Request for Additional Information No. 130, Supplement 1 (1430, 1461), Revision 0

U. S. EPR Standard Design Certification

SRP Section: 03.07.01 - Seismic Design Parameters

SRP Section: 03.07.02 - Seismic System Analysis

Figure 03.07.02-2-1—Shear Wave Velocities of the Generic Soil Profiles

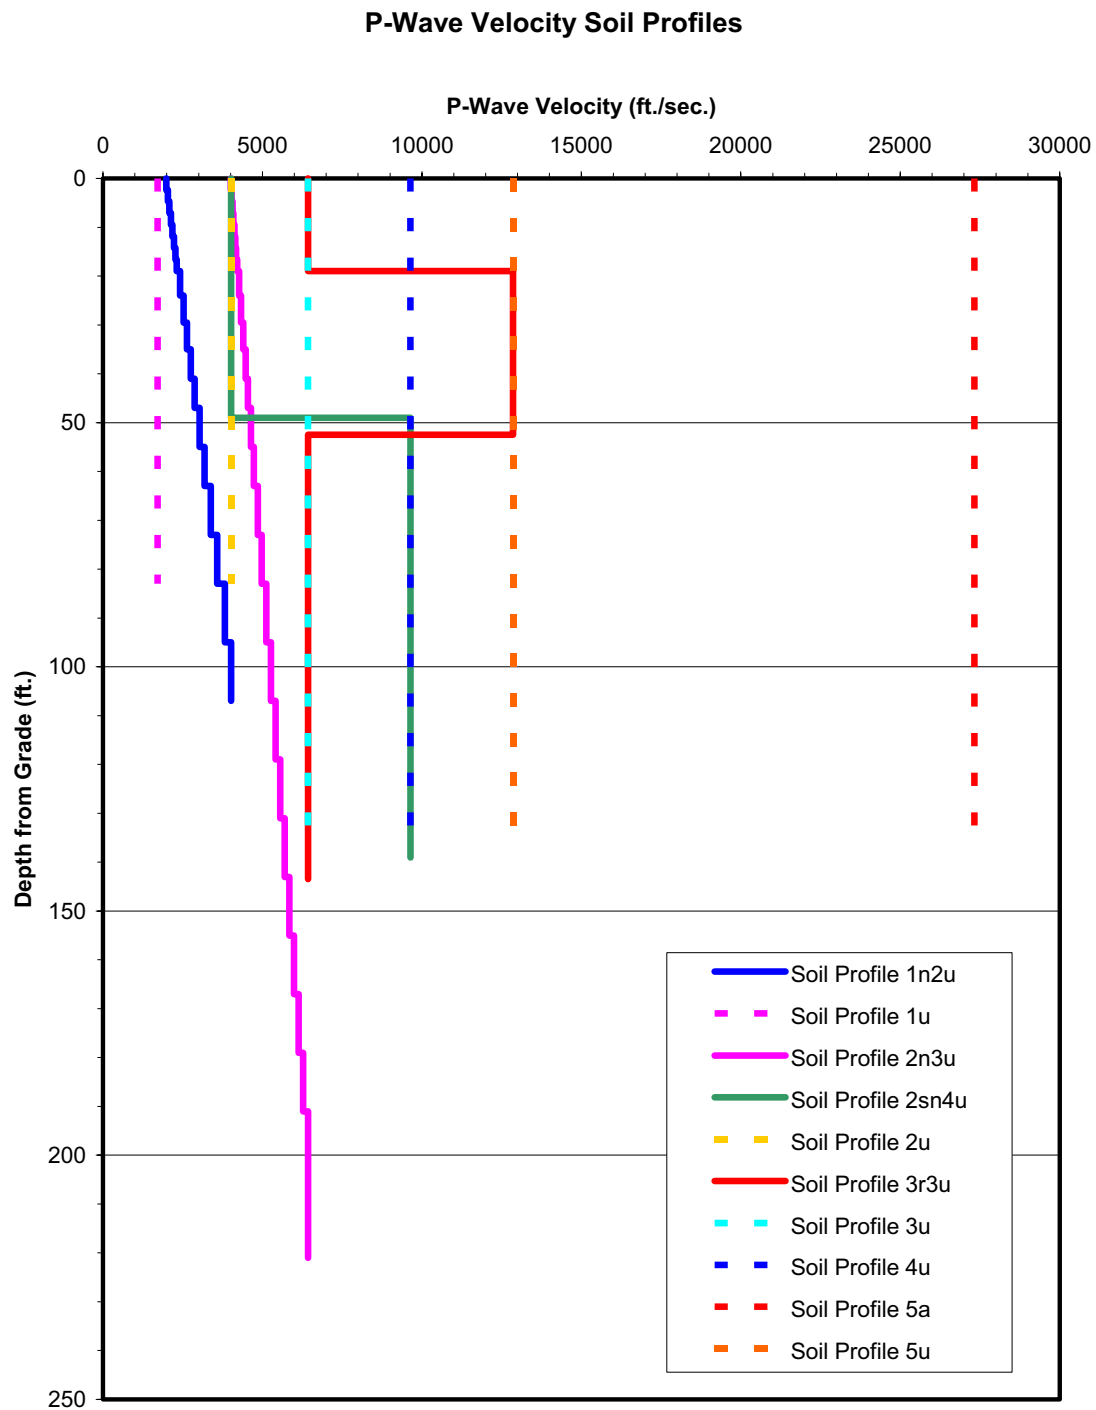
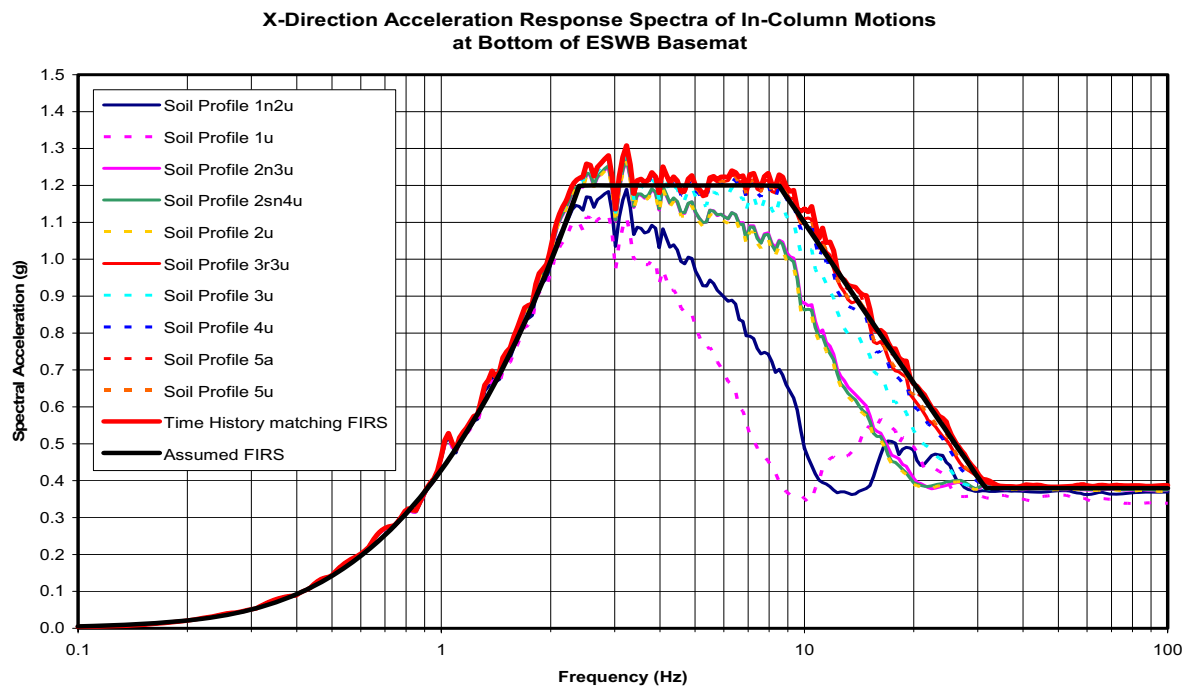
In FSAR Section 3.7.2.1.3 (pg 3.7-69, 4th paragraph), it indicates that the complex frequency response analysis method is also used in the soil column analysis using Bechtel computer code SHAKE2000, Version 1.1, to compute the free-field “in-ground” motion at the foundation level of ESWBs, for use as the input motion to the SSI analysis. This is indicated to be needed to incorporate the effects of embedment in the SSI analysis of the ESWBs. The input ground motion specified in Section 3.7.1 corresponds to a hypothetical free-field “outcrop” motion at the foundation level of ESWB. Bechtel code SASSI 2000 requires that the input motion, when specified at the foundation level, must be an “in-ground” motion converted from the “outcrop” motion through a soil column analysis. Please indicate if, in generating “outcrop” motions using the SHAKE Code whether the soil column above the foundation level (a depth of about 6.7 m (22 ft)) below grade) is removed from the soil column as required by both the SRP and the ISG. The “outcrop” must be defined assuming no soil above the level of the “outcrop” depth and all potential effects of down-coming waves need to be removed from the computation. Provide analytic modeling, outcrop and in-ground spectra, FIRS, soil conditions and numerical results to indicate how the SHAKE computations are performed.

- The generic soil column models are shown by the plot of shear wave and P-wave velocities in Figure 03.07.02-2-1 (same as shear wave velocities shown in U.S. EPR FSAR Tier 2, Figures 3.7.1-31 and 3.7.1-32) and Figure 03.07.02-2-2. No iteration is allowed for these SHAKE analyses.
